Official Transcript of Proceedings
NUCLEAR REGULATORY COMMISSION

Title: Advisory Committee on Reactor Safeguards
 Plant License Renewal Subcommittee

7 PLANT LICENSE RENEWAL SUBCOMMITTEE

8 DIABLO CANYON POWER PLANT

DCPP THIMBLE TUBE L-13 HISTORY

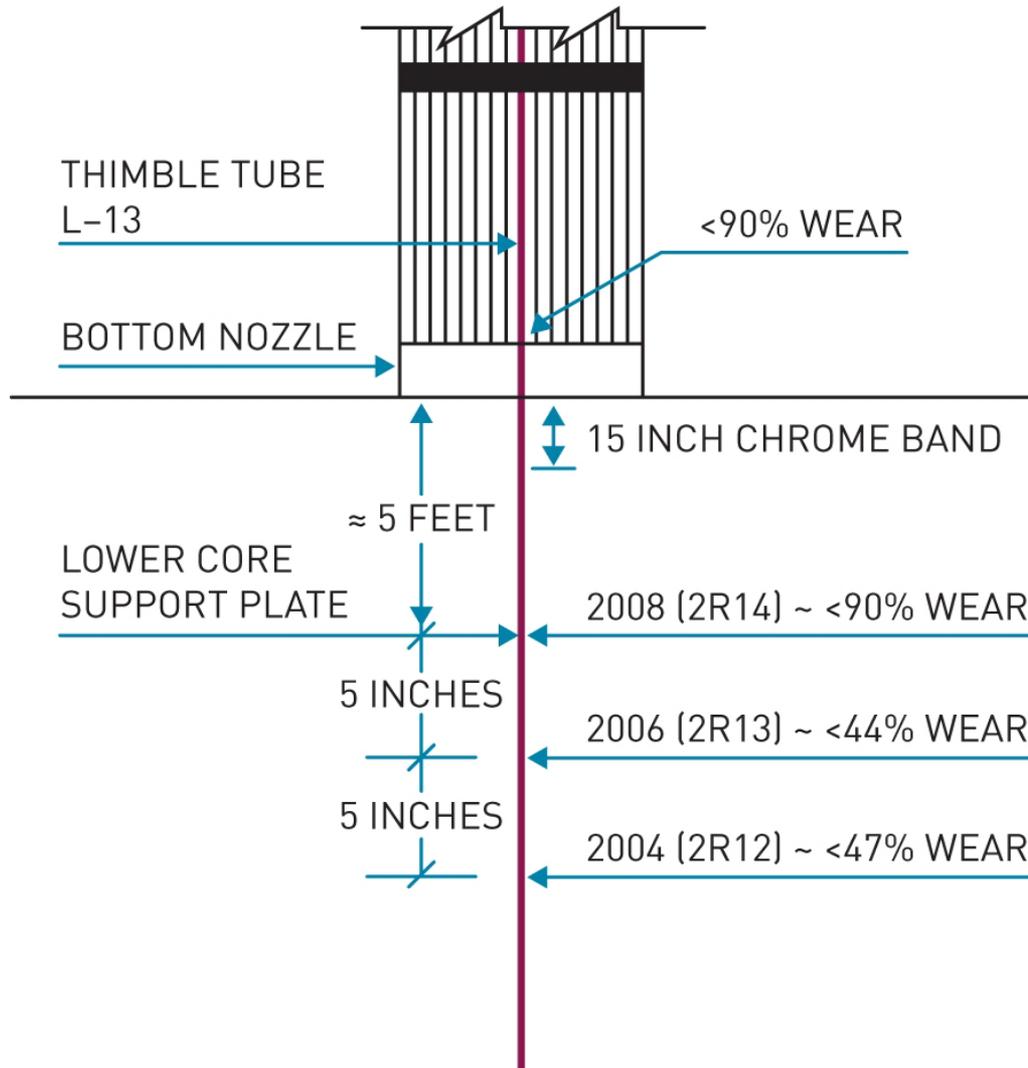
9 Slide 18, please. Now I will address
10 the open item. There are two aspects of the open
11 item, the first being that the Diablo acceptance
12 criteria does not specifically include a value
13 for instrument and wear scar uncertainty. We
14 were asked to verify that we have the appropriate
15 margin to account for them.

6 In 2R14, L-13 was removed from the
7 plant in 2\$14 following eddy current testing
8 examination. There were two high wear locations
9 that were identified greater than 90 percent on
10 the L-13 with eddy current examinations.

11 As a result of the L-13 cause
12 analysis, again from cycle 14, we have added
13 additional nonlinear wear acceptance criteria
14 that I will describe in a couple of slides. In
15 total, we believe that the combination of the 68
16 percent wear in addition to the nonlinear
17 acceptance criteria is both conservative and
18 comprehensive.

15 Since application of these new non-
16 linear acceptance criteria, 31 tubes have been
17 removed from service in the last five refueling
18 outages. Of these 31 tubes, 67 percent were due
19 to this exceeding the non-linear wear criteria.
20 So the message here is the additional criteria we
21 put in place has been effective in identifying
22 tubes to replace.

Flaw Growth Evaluation for RHR Piping Weld WIC-95

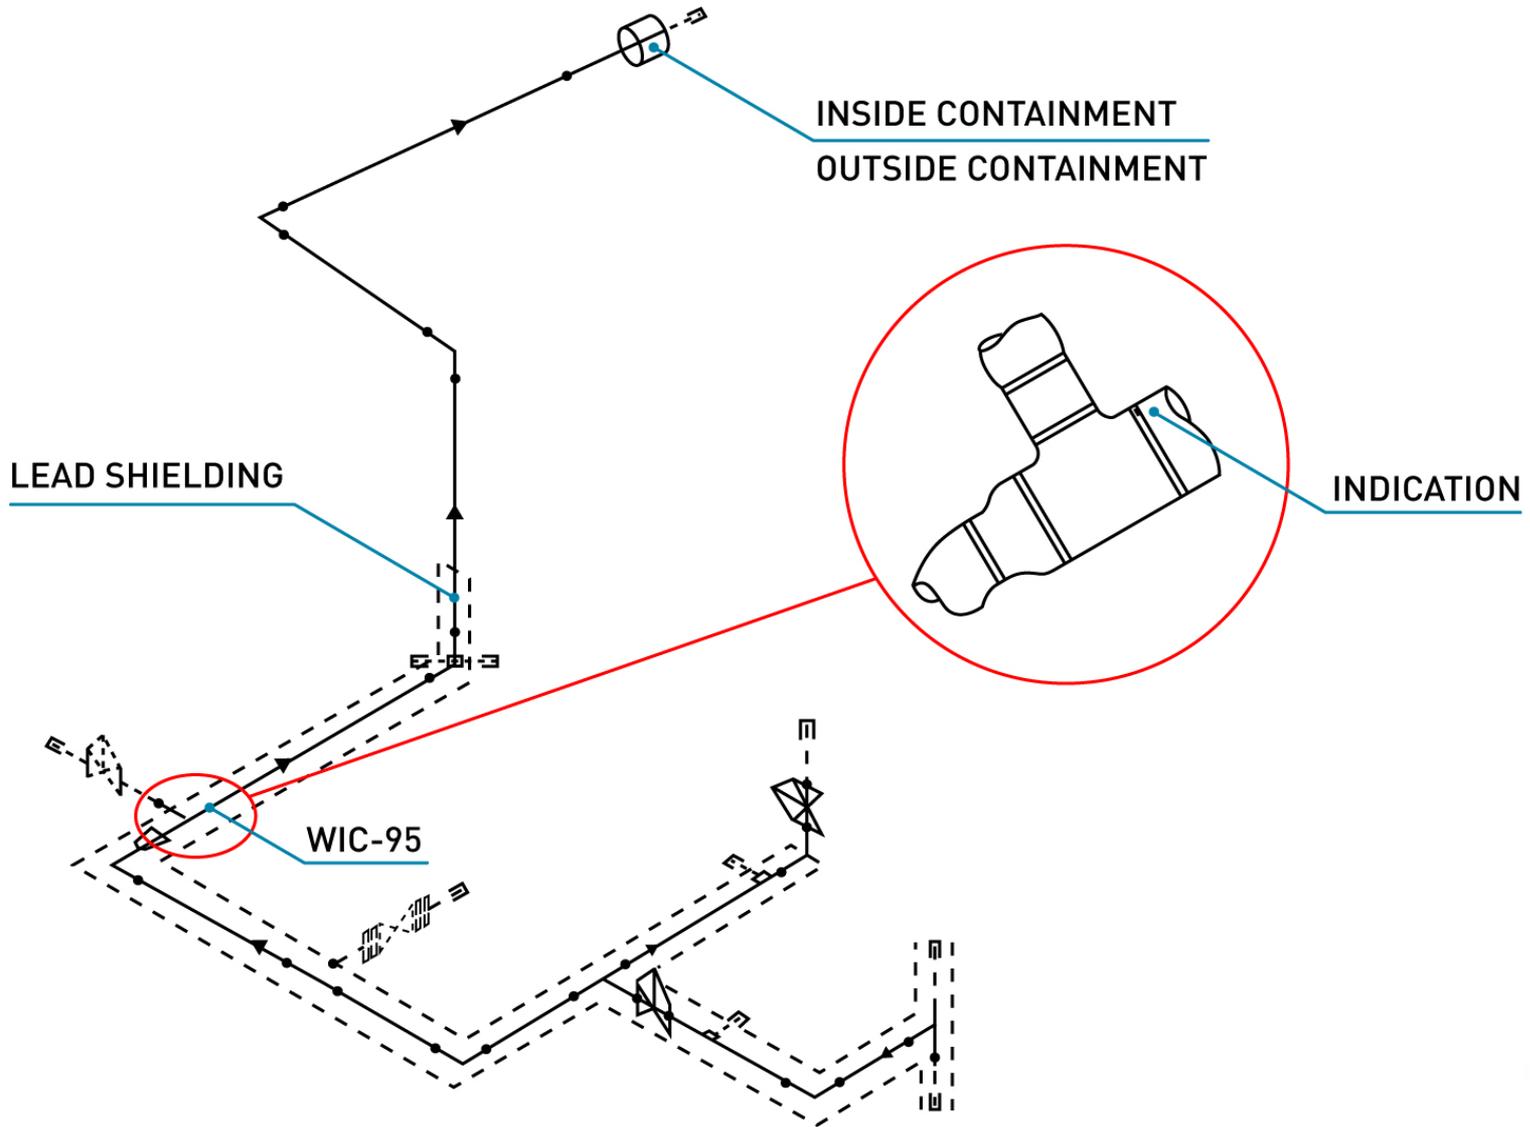
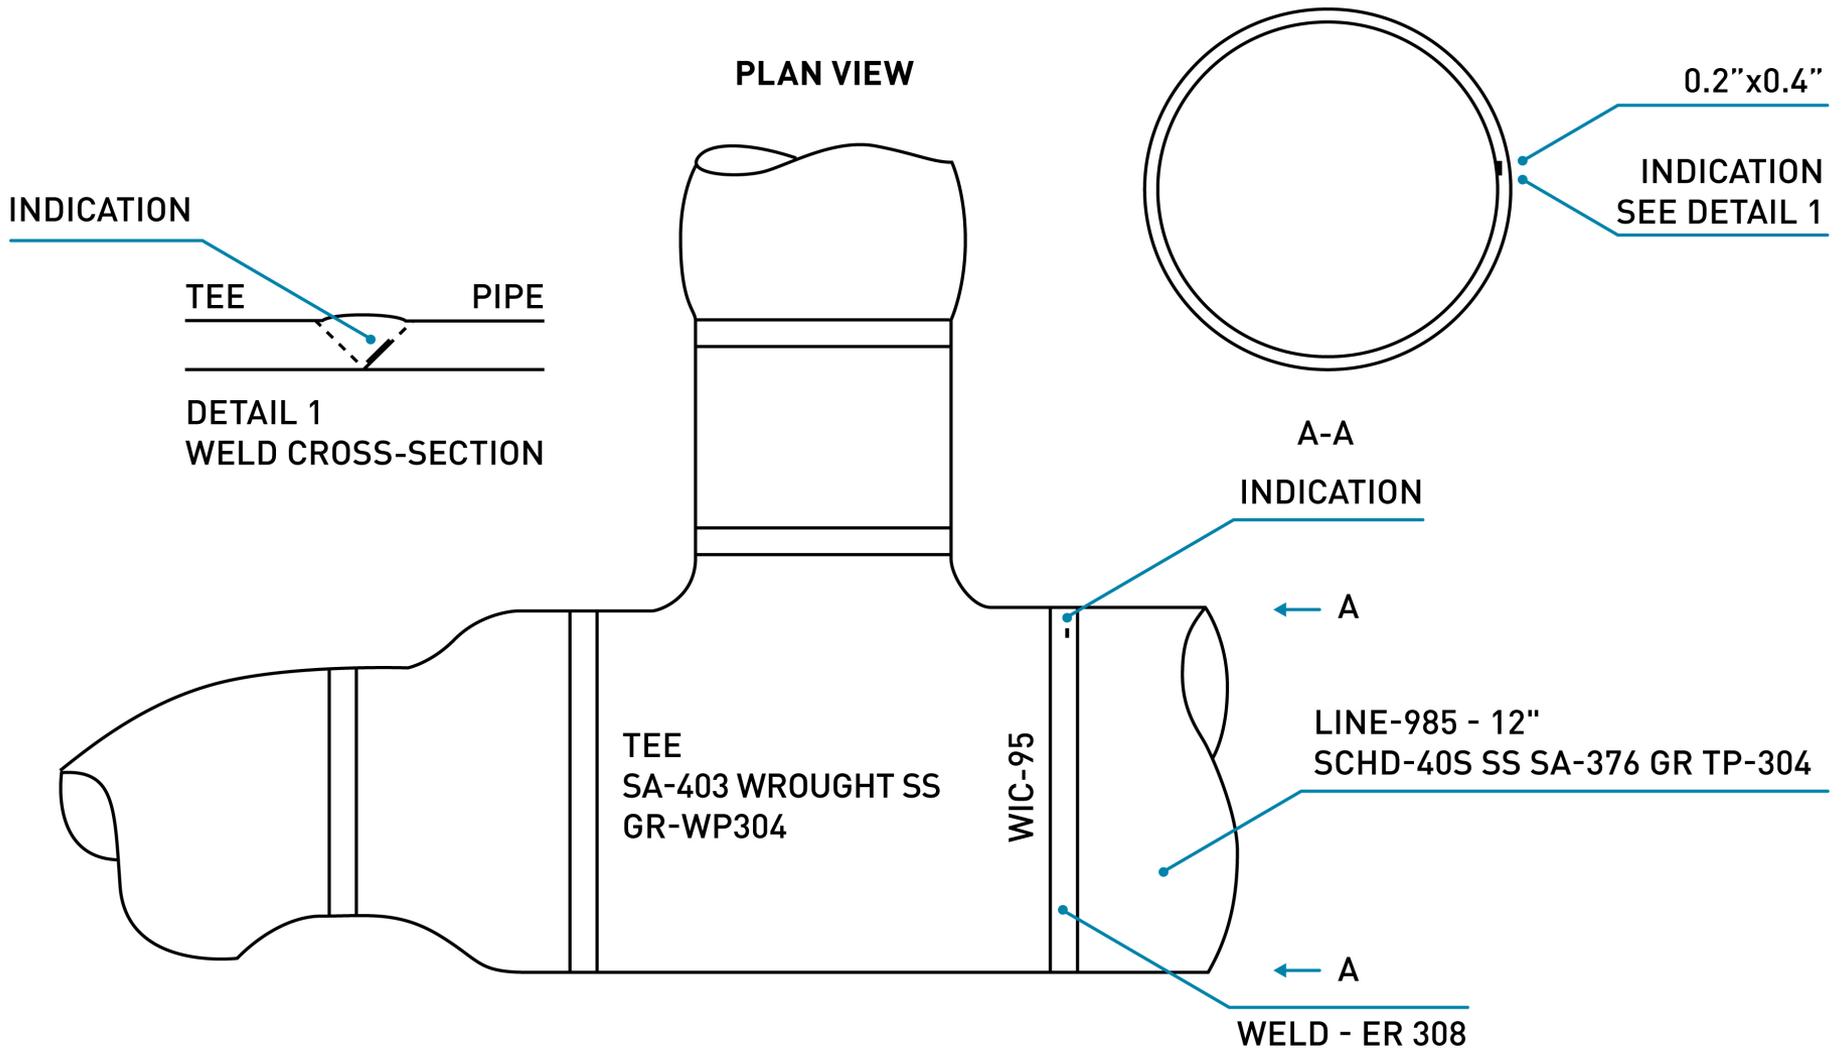
13 So this line is the residual heat
14 removal system, stainless steel pipe, 12 inches
15 diameter, and about .4 inches thick. The
16 specific weld I am addressing is identified as
17 WIC-95, and is pipe to tee weld and as shown on
18 this isometric drawing, Miranda is highlighting
19 that location now.

16 So in answer to your question, sir,
17 the tee is 403 wrought 304 stainless steel. So
18 it a wrought tee, and the pipe is also, as
19 depicted there on the righthand side. That is a
20 12 inch Schedule-40 stainless steel, also 304,
21 and the weld material would be our ER 308.

- PG&E's basis for concluding that the flaw in Unit 1 RHR piping weld WIC-95 is not service-related
- PG&E's flaw analysis for this weld did not address stress corrosion cracking (SCC)

- Evaluated the characteristics of the flaw as non-service induced
- Fatigue crack growth evaluated with acceptable results
- Subsequent 2000 UT inspection result consistent with non-service induced (no growth)

- SCC evaluation performed with acceptable results
- Confirmatory UT inspection of WIC-95 during the 2012 outage
